1 Products affected

2 Type of change

Product Change Notification					PCN Fusedrawer 2		
owner	creation date	release date	released by	change order no	rev	page	D10-017-137
sariogar	21.09.2017	22.09.2017	buerglal	2013754	C	1 of 3

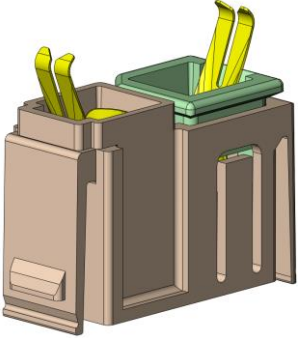
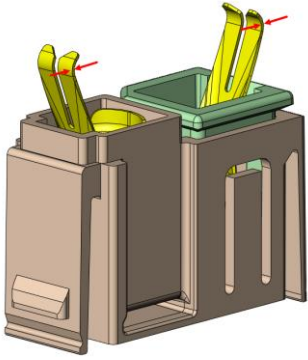
Old contact spring thickness 0.20 mm	New contact spring thickness 0.25 mm

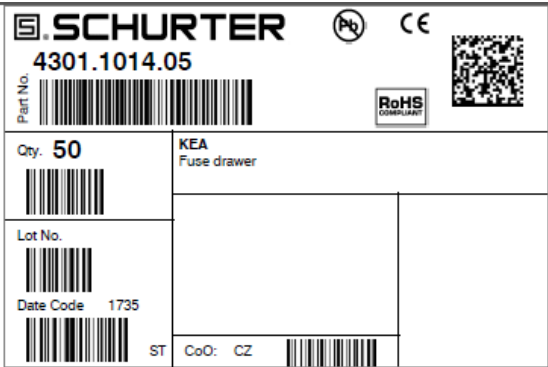
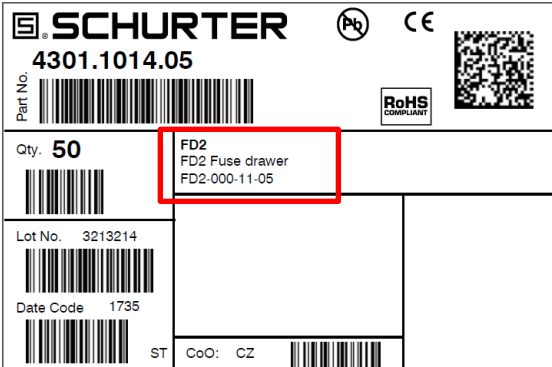
Old label	New label
	<p>Name and description adjusted. Configuration code added.</p>
